AmerGen Energy Company, LLC
Three Mile Island Unit 1

SUBJECT: THREE MILE ISLAND NUCLEAR STATION, UNIT 1 (TMI-1),
OPERATING LICENSE NO. DPR-50
DOCKET NO. 50-289
SUPPLEMENT NO. 1 TO TECHNICAL SPECIFICATION CHANGE REQUEST NO.
262, SECTIONS 1, 3, AND 4 IMPROVEMENTS

Enclosure 1
Supplement to TMI-1 Technical Specification Change Request No. 262
And No Significant Hazards Consideration Analysis

TECHNICAL SPECIFICATION CHANGE REQUEST (TSCR) No. 262

FIGURE 1**"TYPICAL TEST OVERLAP"****Safety Evaluation**

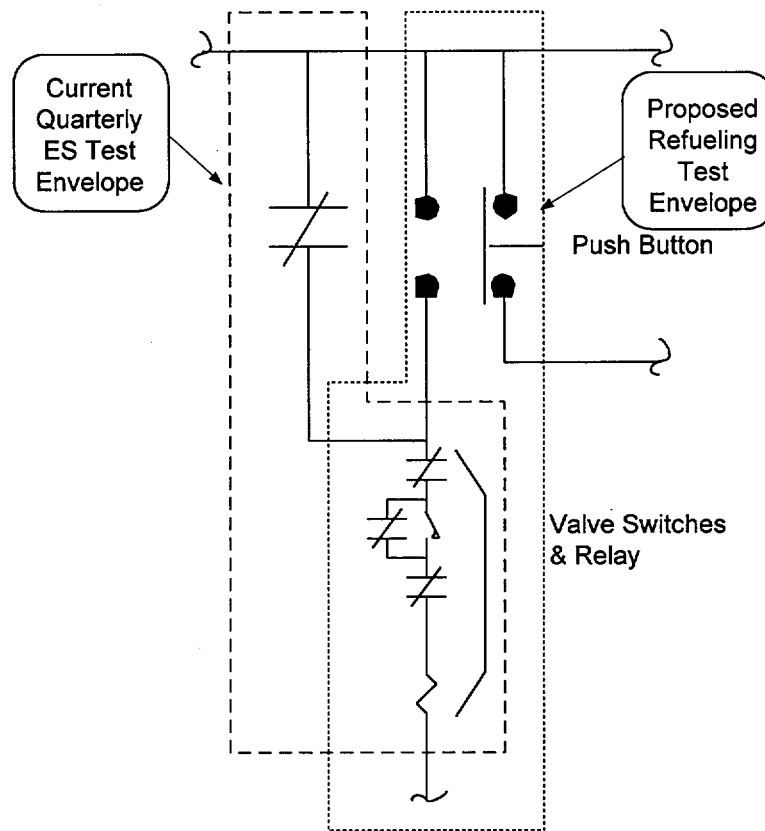
Tech Spec 4.5.2.1 requires that a high-pressure injection system performance test be performed each refueling interval. The current specification requires that testing must be done by an operator starting the pumps and a test signal must be used to open the valves. The requirement to use a "test signal" to open the valves adds complexity to the testing without adding value. Other Technical Specifications provide requirements to ensure that the high-pressure injection valve actuation logic is tested (TS 4.1-1 item 14) and the valve operation is tested (TS 4.2.2 & 4.5.2.4.a). These tests are performed quarterly using the ES logic test signal. During the refueling interval, the high-pressure injection performance test, adds complexity. The operators must carefully manipulate the ES test features and verify that only the desired components are actuated, at a time when their attention must also consider low-temperature over protection issues and verification of proper high-pressure injection component and system performance. Removing the ES test signal requirement would allow the valves to be opened as part of the test setup and the risks associated with inadvertent ESAS actuation would be minimized. This revision to 4.5.2.1 removes the requirement to use the test signal to open the valves and uses the measured flow to confirm system performance.

ESAS Quarterly logic testing proves two-of-three logic by alternately sending signals to injection pumps and valves. Although quarterly logic testing does not flow water in the High Pressure Injection, Low Pressure Injection, or Reactor Building Cooling systems, part of the test starts the pumps, followed by another part of the test that strokes the injection valves. Valve travel is stopped by an open limit switch in the valve operator and is independent of the open signal.

The OPEN pushbutton contact is in parallel with the quarterly tested ES contact. The refueling interval test of the valve is an overlapping test with the quarterly logic test because in both cases the same limit switch in the valve operator stops travel. Using the open pushbutton to initiate travel rather than the ES contact does not affect where the valve stops traveling. Figure 1 illustrates typical contacts that are tested during the aforementioned tests.

The OPEN pushbutton contact is in parallel with the quarterly tested ES contact. The refueling interval test of the valve is an overlapping test with the quarterly logic test because in both cases the same limit switch in the valve operator stops travel. Using the open pushbutton to initiate travel rather than the ES contact does not affect where the valve stops traveling. See Figure 1 under paragraph G for typical contacts that are tested.

~~The makeup pump and its required supporting auxiliaries will be started manually by the operator and a test signal will be applied to the high pressure injection (HPI) valves MU-V-16A/B/C/D to demonstrate actuation of the high pressure injection system for emergency core cooling operation.~~

- b. The test will be considered satisfactory if the valves (MU-V-14A/B & 16A/B/C/D) have completed their travel and the make-up pumps are running as evidenced by **system flow** ~~the control board component operating lights~~. Minimum acceptable injection flow must be greater than or equal to 431 gpm per HPI pump when pump discharge pressure is 600 psig or greater (the pressure between the pump and flow limiting device) and when the RCS pressure is equal to or less than 600 psig.
